# Access Compliance Report

## Public Rights-of-Way

### (Curb Ramps)

Intersection ID: 26458	Main Street: BRECHIN_DR	Cross Street: BROADFORD_CT	Location: NE
ADA ID: BBD682A0977F	Ramp Type: Perp	Initial Pass/Fail: Fail	Overall Compliance: No
Severity Score: 48.75			
Codes/Mitigation Info/Possible Solution		Field Measurements/Component Compliance

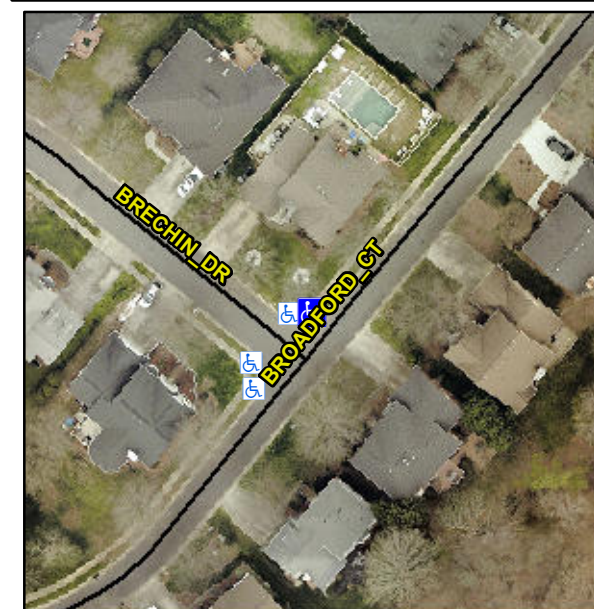
**R304.5.1, R304.2.2, R304.5.3**

Compliance	Description	Data	Compliance	Description	Data
N/A	Ramp Length (in)	94.0	No	Ramp Slope (%)	8.8
No	Ramp Width (in)	27.0	No	Ramp XSlope (%)	2.5
N/A	Flare Type LT	N/A	N/A	Flare Type RT	N/A
N/A	Flare Slope LT (%)	N/A	N/A	Flare Slope RT (%)	N/A
N/A	Flare Traversable LT?	N/A	N/A	Flare Traversable RT?	N/A
N/A	Landing Length (in)	N/A	N/A	DWS Provided?	N/A
N/A	Landing Width (in)	N/A	N/A	DWS Contrast?	N/A
N/A	Landing Slope (%)	N/A	N/A	DWS Length (in)	N/A
N/A	Landing X Slope (%)	N/A	N/A	DWS Full Width?	N/A
N/A	Landing Curb? (Y/N)	N/A	N/A	DWS Offset (in)	N/A
N/A	Shared Landing?	N/A			
N/A	Gutter Ponding?	N/A	N/A	Gutter Slope (%)	N/A
N/A	Gutter Lip Ht (in)	N/A	N/A	Gutter X Slope (%)	N/A
N/A	Painted X Walk1?	No	N/A	Painted X Walk2?	N/A
	X Walk 1 Direction	To SE		X Walk 2 Direction	N/A
N/A	X Walk 1 Width (in)	N/A	N/A	X Walk 2 Width (in)	N/A
	X Walk 1 Slope (%)	1.1		X Walk 2 Slope (%)	N/A
	X Walk 1 X Slope (%)	0.6		X Walk 2 X Slope (%)	N/A

**Remove & Replace Entire Ramp.**
